Charlotte Historic District Commission

Application for a Certificate of Appropriateness August 10, 2011

ADDRESS OF PROPERTY 1920 South Mint Street, Wilmore Local Historic District HDC 2010-107

SUMMARY OF REQUEST Second Floor Addition – Change in Previously Approved Plans

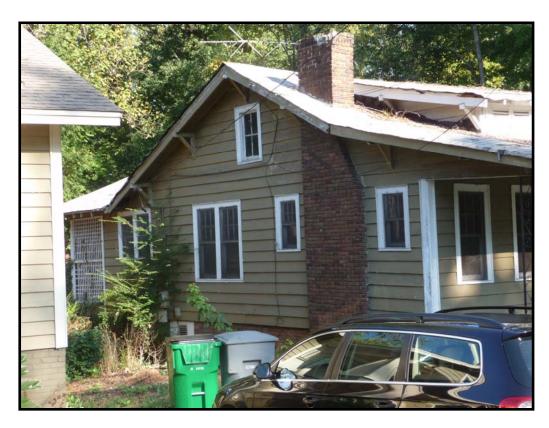
The attached plans show a story and one half structure that is very much in keeping with the overall style of the existing house. Under this plan, the house would become slightly over 22 feet in height above the finished floor, with the foundation wall being raised I the rear to accommodate the slope of the lot.

The two front facing shed vent dormers are replaced by two taller windowed dormers, retaining the style of the original house.

The overall fenestration appears to be appropriate to both the scale and the style of the house. The proposed siding material is wood clapboard.

The only detail that appears to need further study is the proposed use of vinyl replacement windows. Although wood is preferred under current HDC policy, vinyl coated wooden windows have been approved when a sample of the proposed window is reviewed, often by HDC staff.
